Product Change Notification

Date Issued :	January 16, 2023	PCN Number :	513244
Reason for Change :	Change to Product		
Description of Change :	This notification is to inform you about changes that are being made to the part(s) as identified in the list based on the replacement of aged tooling at Molex Lincoln Nebraska. This change will not affect the Fit, Form or Function of the product but Will affect the Appearance of the product at the Locking Latch location.		
Assessment of Change :	First Article Inspection Reliability Test Report/s		
Planned Implementation Date :	July 17, 2023		
Sample Availability Date:	April 21, 2023		
Internal Molex Qualification Date :	May 19, 2023		
Last date to request Samples by Customer :	June 30, 2023		
Traceability Code Markings / Date :	Cavity identification

- 5557 Series
 - Mini-fit JR 3ckt receptacle

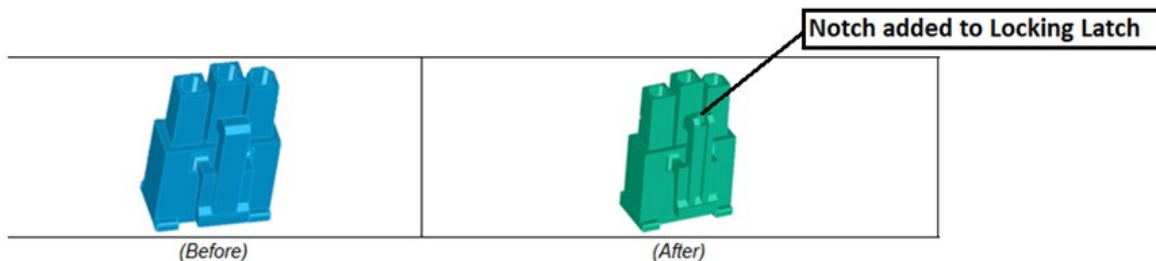
- To ensure business continuity, Molex Lincoln Nebraska is needing to replace tooling for the Mini-Fit Jr 3ckt receptacle due to the age of the current tool.
 - New tooling will be changed to improve mold flow during part production
 - Product from the New tooling from Lincoln Nebraska will have a notch added to the Locking Latch
 - Notch in Locking Latch is to improve mold flow and reduce short fill of product
 - Product made from other locations will not have this notch
- Change will impact Appearance of the part at Locking Latch location
- There will be NO change to the Fit, Form or Function of the parts
- Part Numbers Impacted
 - See attached list
- Qualification and Samples available upon request after date shown above
